# TECHNICAL INFORMATION JDE

Type <b>Coffee Vending Machine</b>	Model <b>9100</b>	T.I. NO <b>08 - 2017</b>		
Serial Number <b>72011867</b>	Subject <b>Standardization of the Touch screen thickness (3 mm)</b>	ISSUED FOR (X)	Action Information	<input checked="" type="checkbox"/>

Display thickness **3 mm**

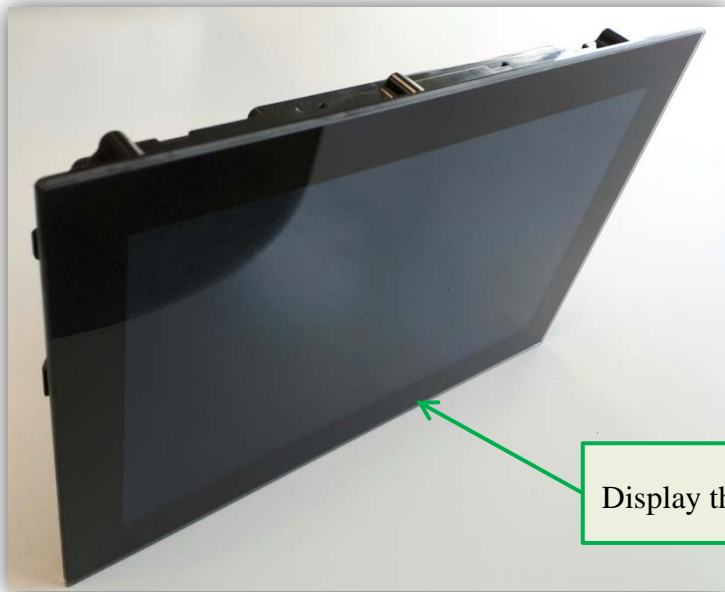
The display **thickness** of the different touch screen versions have been standardized to **3 mm**.

Touch screen assembly - display thickness **3 mm**  
 Spare code: **260321**  
**SAP:55117981 10" TOUCH SCREEN ASSEMBLY-GLASS 3mm**

Touch screen assembly - display thickness **2,5 mm**  
 Spare code: **259783 - It is no longer available**

**Machines concerned by modification from S/N 72011867.**

The **standardized** solution (3 mm) is retrofittable.
